STAKE HOLDER CONSULTATION PROCESS OFFSHORE GRID NL	
Type:	Position paper
Work stream	Technical
Topic:	T.17 – Compliance testing
Filename	ONL-TTB-03069 T17_Compliance testing_PP_V1
Version	1 - Public
Pages	8

QUALITY CONTROL		
Prepared:	TenneT team	
Reviewed:	M. Müller	08.10.2015
Approved:	F. Wester	08.10.2015
Release	Public

Clause 5.2

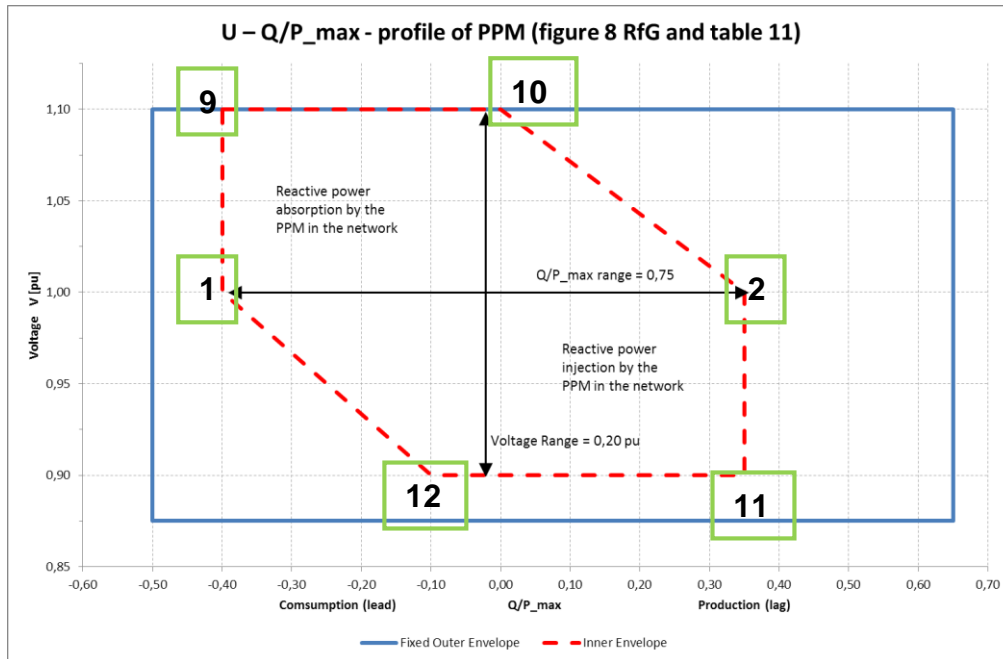
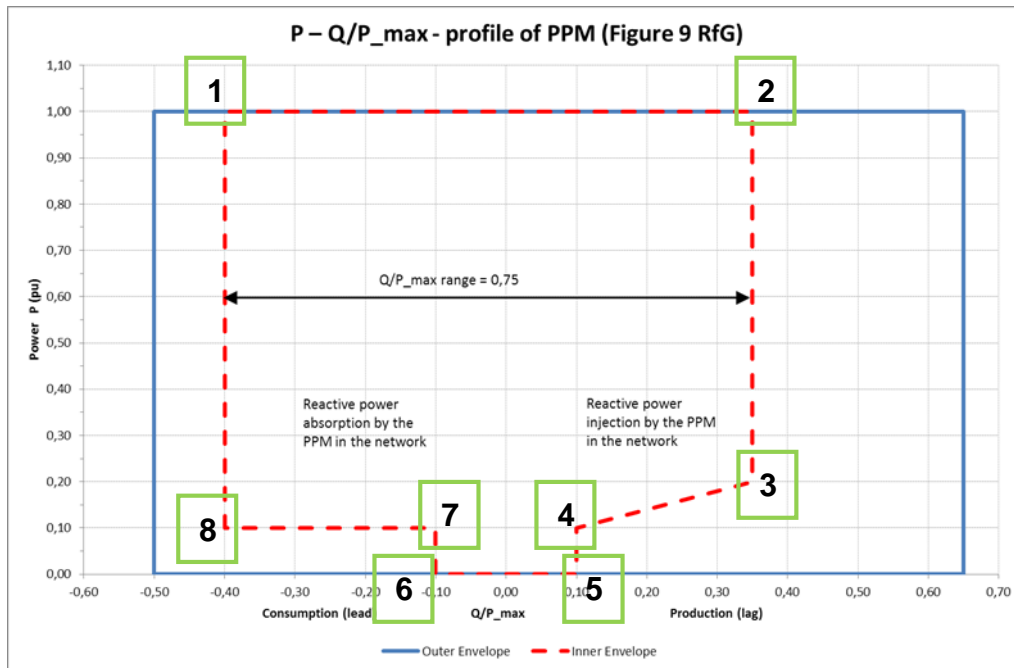
Figure 1 shall be replaced by the applicable figures 'c' and 'd' of annex 6 of the REA.

Figure 'c'

Figure 'd'.
